STUDY TEAM'S LETTER TO COUNCIL OF 27 AUGUST FOLLOWING TECHNICAL MEETING AT COUNCIL ON 24 AUGUST 2012

# RE: MP10-0143 COLUMBIA PRECINCT MIXED USE DEVELOPMENT MATTERS FOR COUNCIL REGARDING CONCEPT APPLICATION

Mixed Use Development, at Columbia Precinct, 2-20 Parramatta Road & 11-13 Columbia Lane, Homebush- MP 10\_0143

## 9.0 Landscape Concept Plan

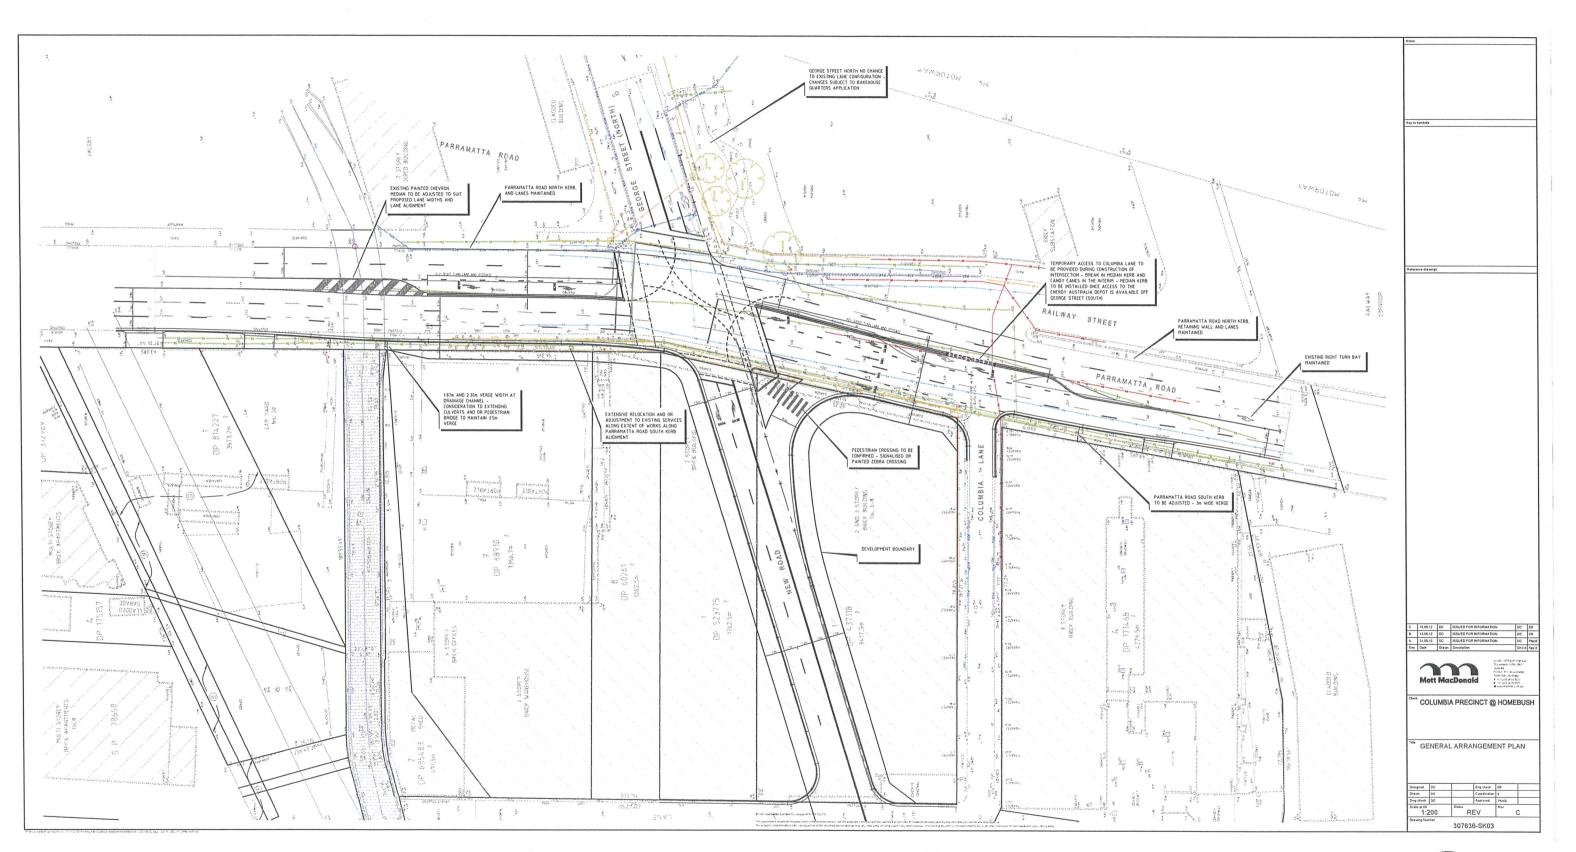
- 2. That part of the Columbia Consortium land fronting Parramatta Road on the western side of the Powells Creek stormwater channel (Lot1/814227 of 3673m²) is currently zoned 6(d) Proposed Open Space, and the owner David Lhuede Pty Ltd has a statutory right to require Council to acquire it for its market value. The Columbia Precinct Concept Application however, proposes to dedicate and improve this land, including pedestrian/cycle bridges across the stormwater channel and Parramatta Road as part of the Powells Creek linear park to Homebush Bay.

- 3. The Concept Plan includes an indicative layout of this proposed open space area only at this stage, and it is accepted that Council will no doubt seek more involvement in the design. As discussed, CBHK and Mayohs were involved in a similar situation in Willoughby LGA, where we worked with Council in designing and then constructing and dedicating a wholly new public park for Council, known as Mashman Park (UBD)

- 4. This is considered a good and cost-effective way of achieving a timely result with minimal disruption to Council's usual activities, however it is acknowledged that Council may wish to deal with it differently. Either way, the agreed value of the land and any construction costs is seen as a Section 94 offset pursuant to S.94 subsection (5). It is certainly not for the sole use of Columbia occupants, nor is it required to satisfy usual resident open space requirements, as they are wholly satisfied within the Precinct itself, by a combination of the various open space shown at Figure A and the SEPP65-compliant balconies to every unit.
- 5. From our discussions on Friday, it is understood that Council's preference is that all other landscaped areas shown at Figure A, hard and soft, would remain in private ownership. [This does not include public roadways, discussed at 'C' below].

- a) Open Space Lands Please confirm if Council is happy to adopt the design and construct methodology as outlined in paragraphs #2 to #4 of Part A of the submission.
